Video Products Technical Bulletin 30-2006-001

SUBJECT: REUSE IC101 WHEN REPLACING A BOARD

MODEL: ***PVM-20S1WE***
PVM-20S1WUSERIAL NO: **ALL***Italicized information in green applies to customers outside the United States.*

Figure 1

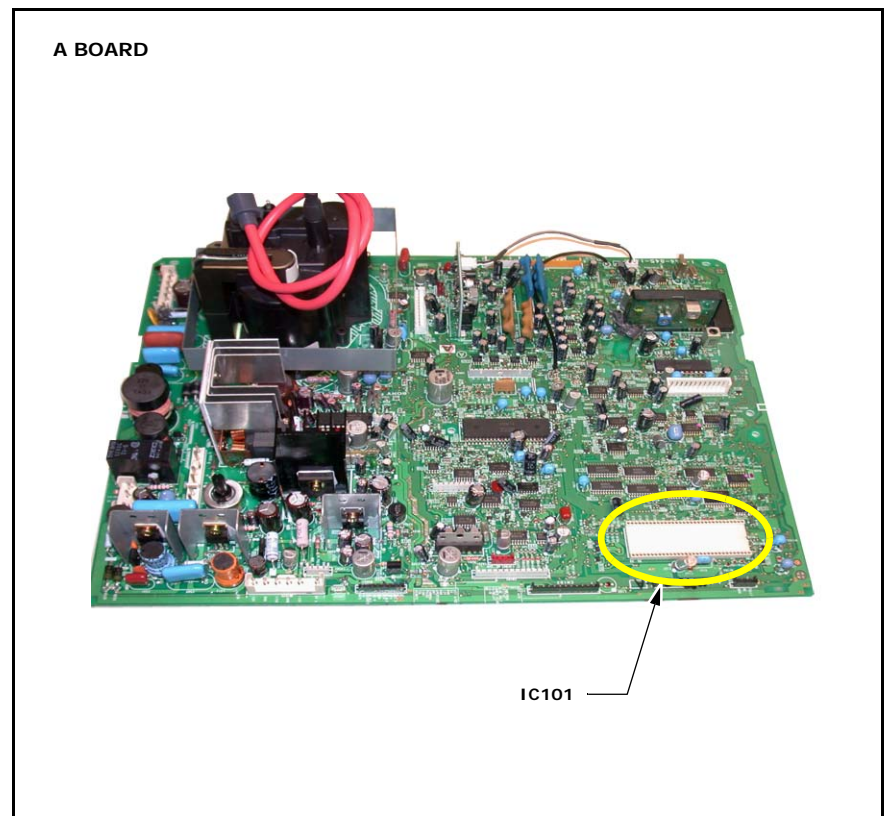
The new A board does not contain IC101, and IC101 is no longer available as a service part. (See Figure 1.)

When you replace the A board (A-1298-044-A), remove IC101 (8-759-546-06, IC UPD78P018FYCW-SW1) from the former board and install it on the new board.
